**MEMORANDUM
FROM THE
DEPARTMENT OF COMMUNITY DEVELOPMENT
ZONING SECTION**

**SUBJECT: Supplemental Staff Report Memorandum
DCI2021-00026, Homes at 81 West RPD**

HOMES AT 81 WEST RPD

MASTER CONCEPT PLAN
REVISED 4/6/2023

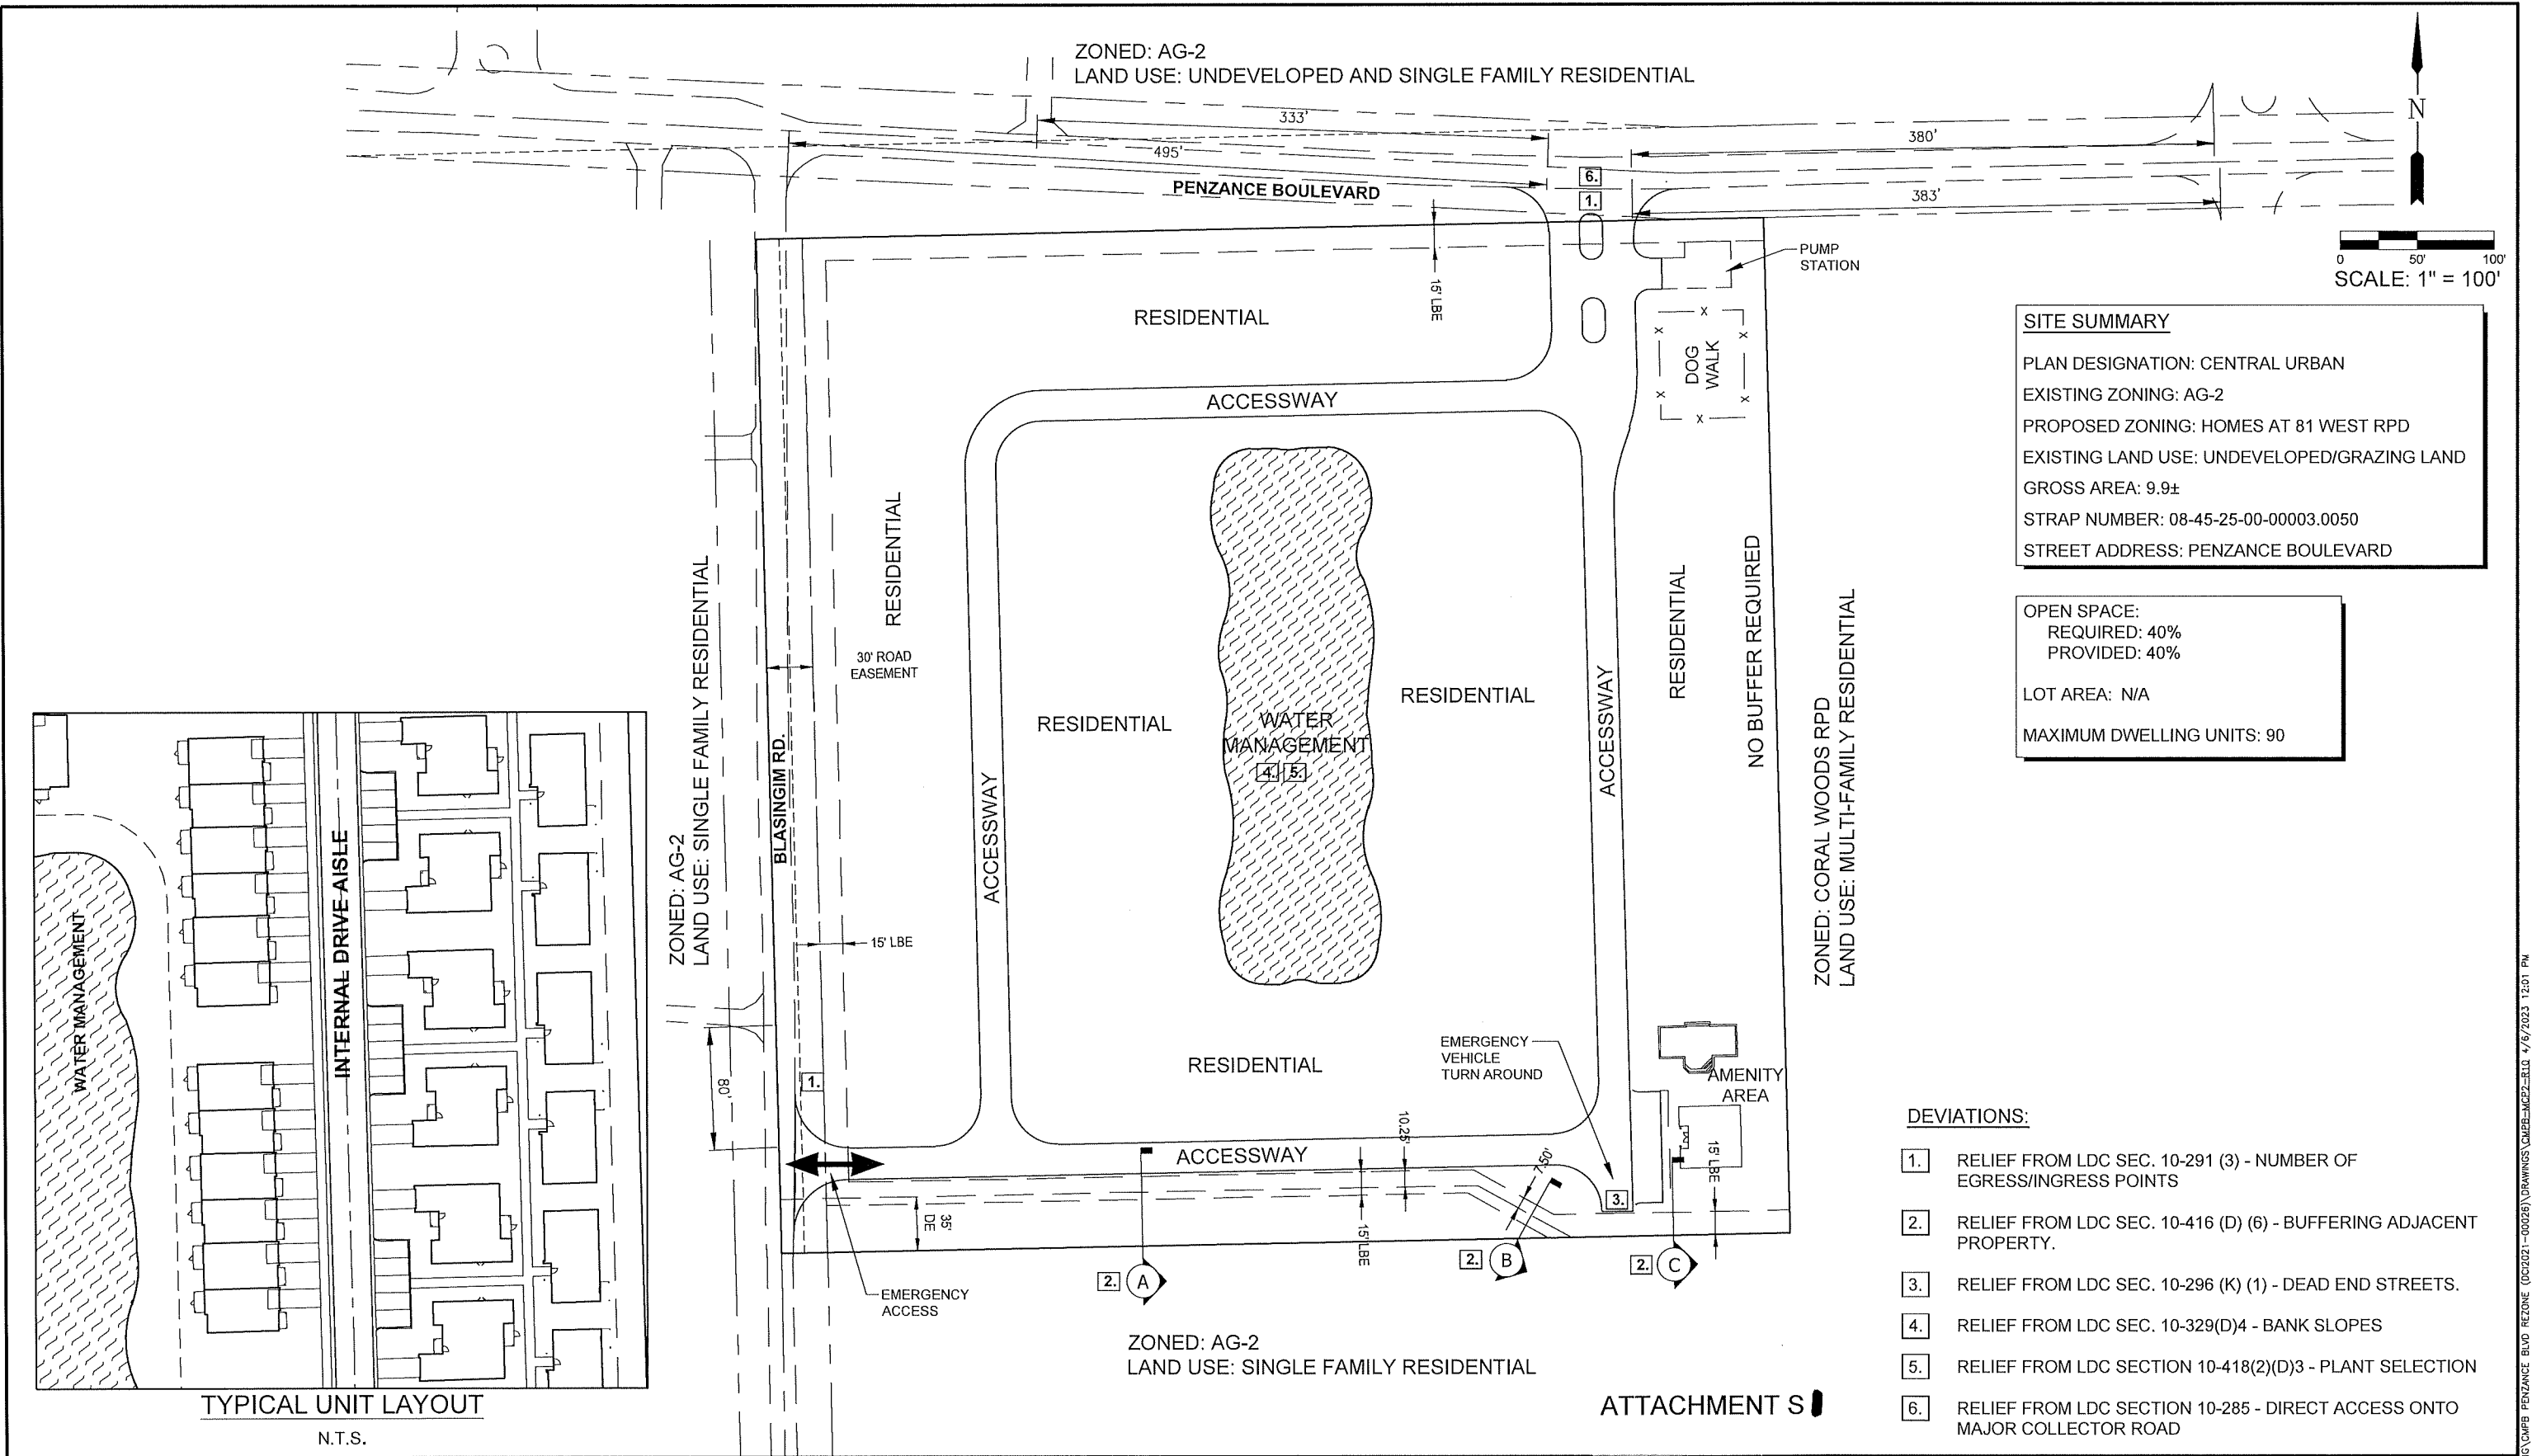
The applicant, in response to the Board's remand and subsequent coordination with DOT, submitted a revised master concept plan and schedule of deviations to address the relief required to relocate the project's access as directed by the Board (see Attachments S1 and S2, respectively). The applicant's justification for the requested deviation notes that Penzance Boulevard is the only feasible access alternative to accommodate the Board's request and that the functional classification of Penzance Boulevard was changed from minor collector to major collector after the subject application was filed. Finally, the applicant's justification notes that the project's access on Penzance Boulevard, as shown on the revised master concept plan, meets the connection separation standards established in LDC Section 10-285.

The justification set forth by the applicant, in the context of the Board's remand, meets the criteria for approval of the requested deviation. The requested deviation will enhance the achievement of the objectives of the planned development by placing the project's principal access point in a location that provides adequate access to the County's roadway network. The requested deviation, as proposed, will also serve to protect public health, safety, and welfare. The revised access location meets the connection separation standards established in LDC Section 10-285 and limits the access on to Blasingim Road, which is currently a privately-maintained local road, to "emergency only;" therefore, staff recommends **APPROVAL** of the requested deviation.

6. Deviation 6 seeks relief from LDC Sec. 10-285, Connection Separation, which indicates that all lots in urban areas with access alternatives will not be permitted direct motor vehicle access to an arterial or major collector, to instead allow the Homes at 81 West RPD to provide primary project access to Penzance Boulevard, which has been classified as a major collector roadway on the County's functional classification map.

This deviation is warranted because the only other roadway that can provide access to the property is Blasingim Road, which is a privately maintained roadway, serving only a small number of single-family homes. At the time the original RPD application was filed with Lee County, Penzance Boulevard was classified as a minor collector and had been classified as such for the past 30+ years. After the application was filed, the road was then reclassified as a major collector, even though there had been no changes to the road. The Administrative Code 11-1 establishes criteria for the determination of the functional classifications for roadways and Penzance Boulevard is substantially more consistent with the criteria established for a minor collector roadway, versus the major collector criteria. This claim is further supported by the fact that Lee County had the road classified as a minor collector for over 30+ years. It should also be noted that there have been many other developments approved along the Penzance Boulevard that directly access Penzance Boulevard based on the minor collector standard. Approval of the deviation does enhance the planned development by placing the primary project access on the collector roadway, rather than a private roadway serving only larger lot single family homes. The proposed access location on Penzance Boulevard does not create any public safety or welfare concerns as the location of the access meets and exceeds the spacing criteria specified in the LDC for both a minor and a major collector classification. Further, the access location on Penzance Boulevard is consistent with the requests by area property owners expressed at a public hearing before the BOCC to place the access on the public roadway rather than the privately maintained Blasingim Road. In response to the residents, the Lee County BCC remanded the case back to the HEX for the reconsideration of whether the project's access should be directly on Penzance Boulevard. The BOCC instructed the Applicant to file the necessary deviations to achieve the desired result. In addition, and per the LDC, a secondary and emergency use only access will be provided on Blasingim Road, which is not expected to be opposed.

- *The project must construct one (1) access onto Blasingim Road in accordance with the requirements of LDC Section 10-296. The Blasingim Road access will be restricted to emergency use only and will remain as such until Blasingim Road is interconnected with the planned extension of Crystal Drive to Plantation Road. The emergency use access must be converted to a standard access to Blasingim Road upon the completion of the extension of Crystal Drive to Plantation Road. This condition does not prevent the construction of a residents/guests only access gate in compliance with LDC Section 34-1748 upon the termination of the emergency use only status.*

This deviation is **APPROVED subject to Condition 4.**

Map 5-2: 2045 Cost Feasible Roadway Projects

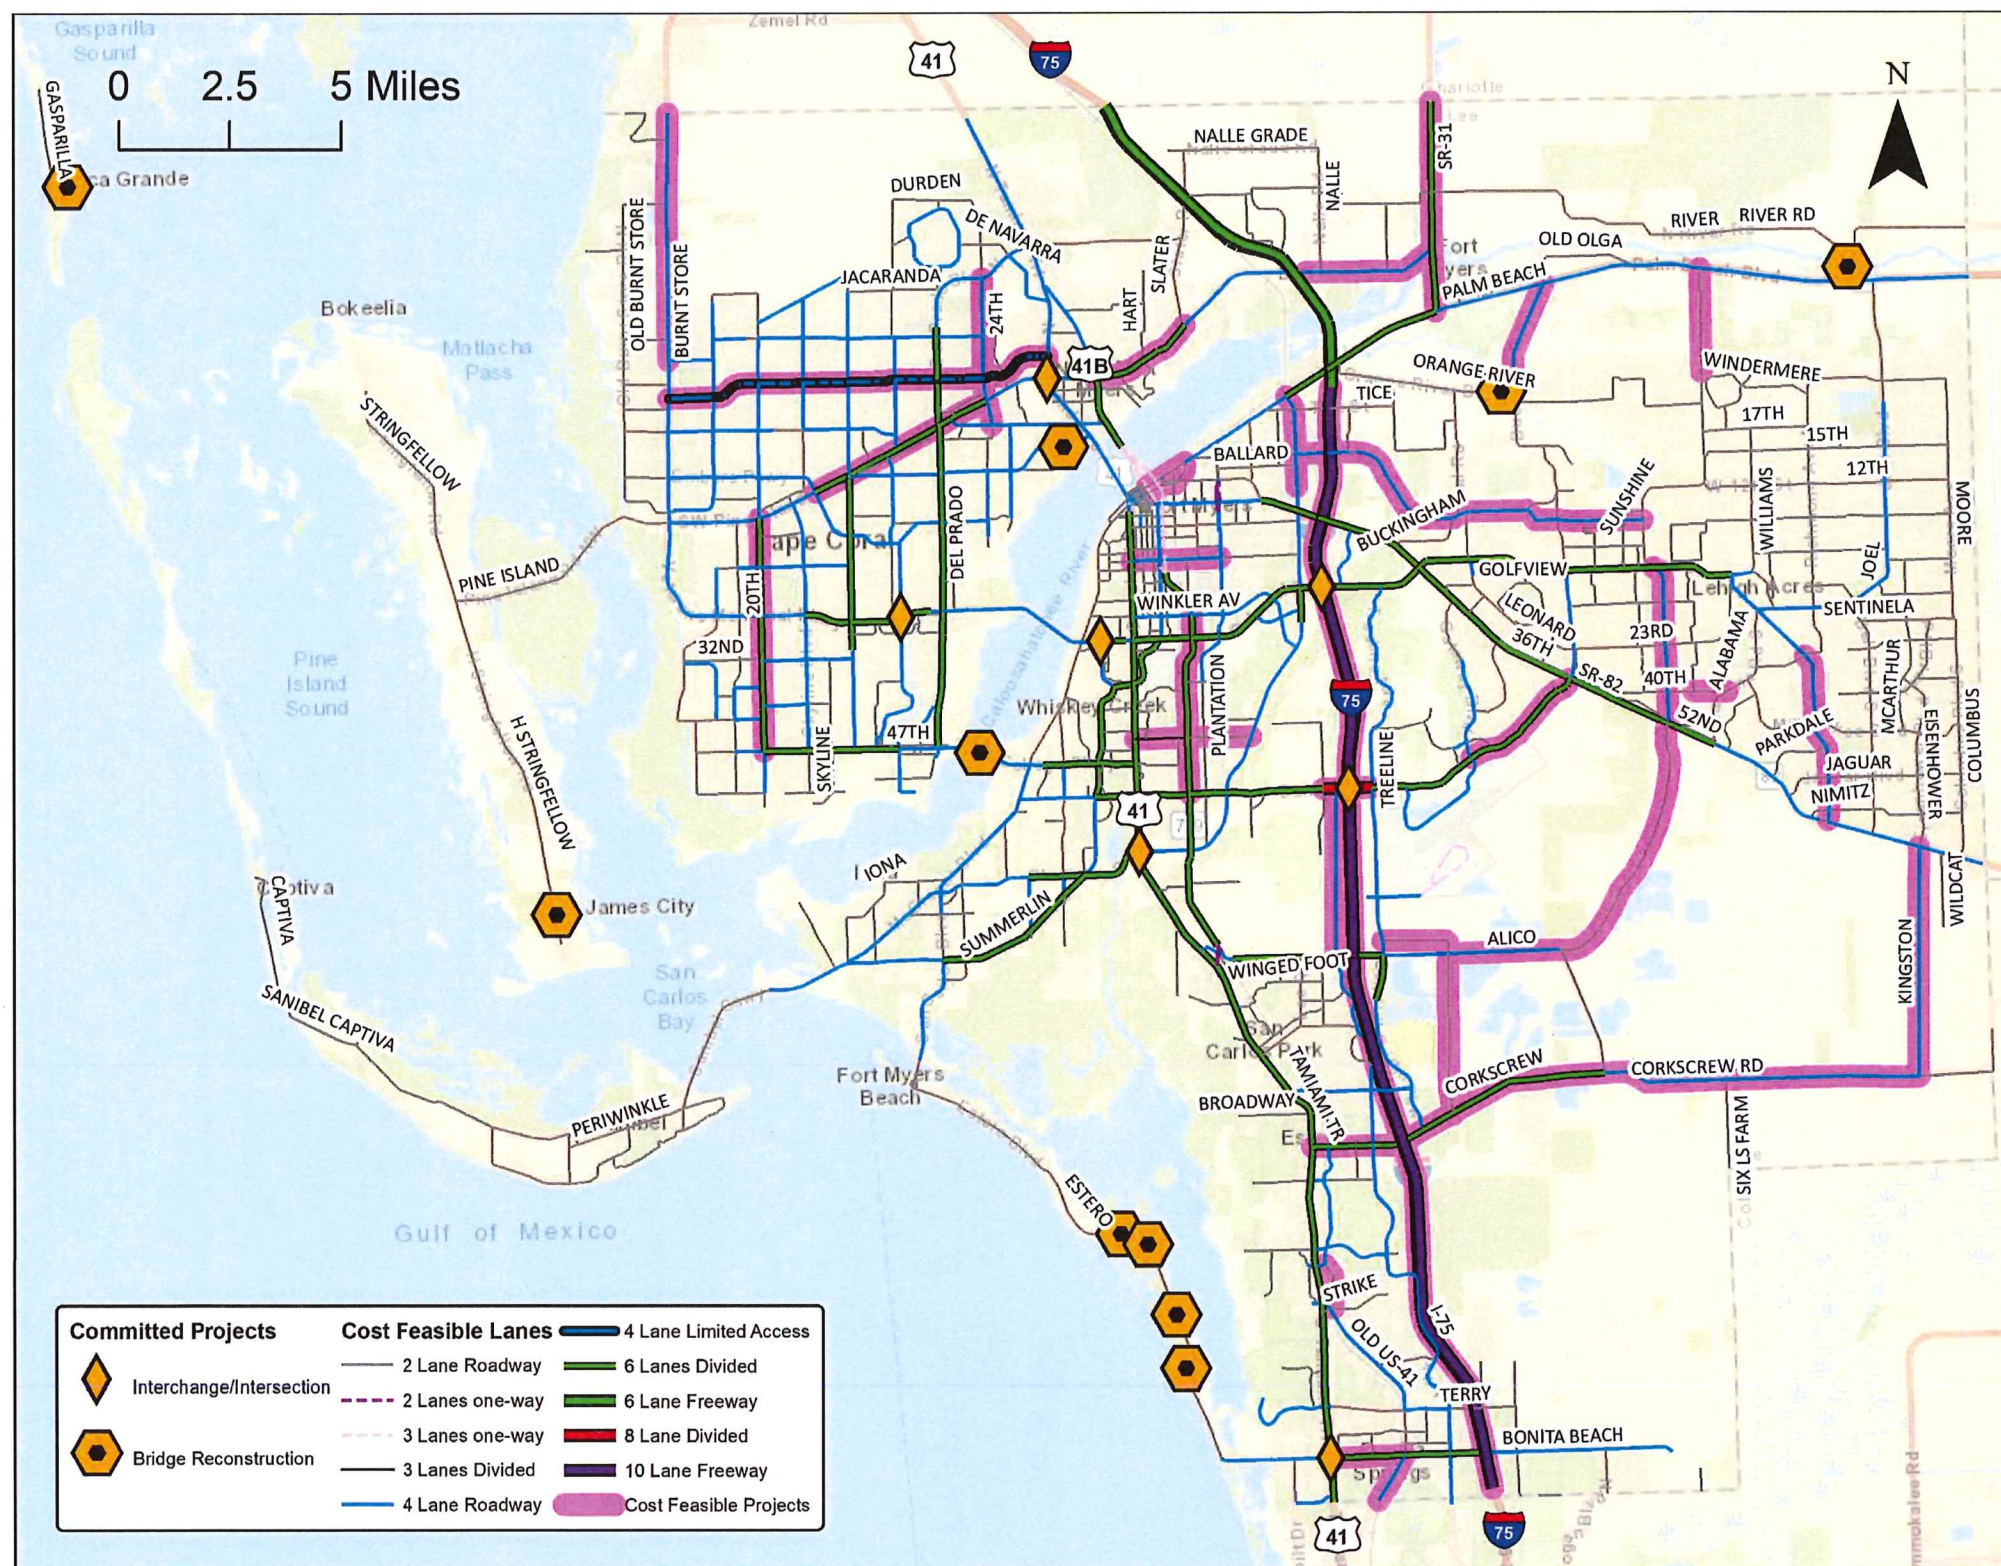
It should be noted that Blasingim Road intersects the right-of-way of Crystal Drive approximately one-quarter mile south of the subject property. The extension of Crystal Drive from Ben C. Pratt/Six Mile Cypress Parkway to Plantation Road is identified as a cost-feasible project in the Lee County Metropolitan Planning Organization's Long Range Transportation Plan, which was adopted in 2020 and last amended in 2023 (see Attachment S4). As such, staff recommends the following additional condition of approval to require construction of the Blasingim Road access in a manner that meets the access design standards set forth by the LDC in order to facilitate access alternatives to the County roadway network for the subject property upon the completion of the extension of Crystal Drive to Plantation Road:
